# Safety Recall

## N232420460 B-Pillar Trim May Interfere with Roof Rail Airbag Deployment

**Revision:** 02

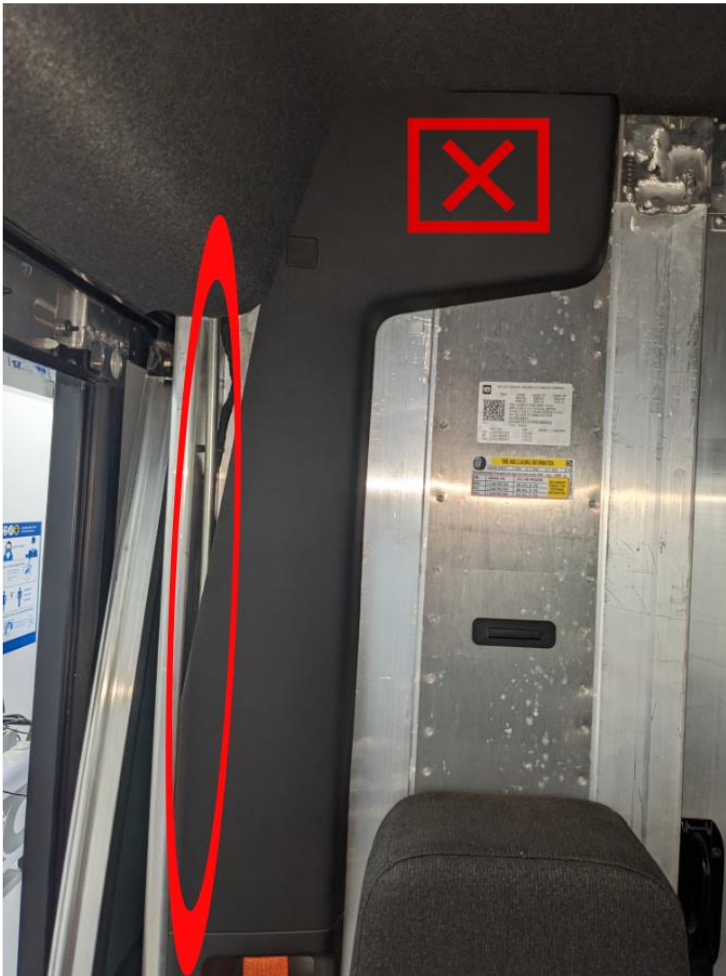
1. Inspect the B pillar trim panel on the passenger's side to determine if it is the correct variant per the above pictures.
  - If the B pillar trim panel is diagonally trimmed in the top left corner AND the airbag rail is visible all the way down to the bottom of the seatbelt bezel portion of the trim panel, no further action is required.

- If the B pillar trim panel has any of the following conditions, replace it. Refer to *Center Pillar Upper Trim Panel Replacement - Right Side* in SI.

- i. The B pillar trim panel is diagonally trimmed in the upper left portion, but the airbag rail is NOT visible all the way down to the bottom of the seatbelt bezel portion of the panel.

- ii. The B pillar trim panel not trimmed at all in the upper left portion, and the airbag rail is not visible at all.
    - iii. The B pillar trim panel is diagonally trimmed and the airbag rail is visible, but only to the TOP of the seatbelt bezel portion of the panel.
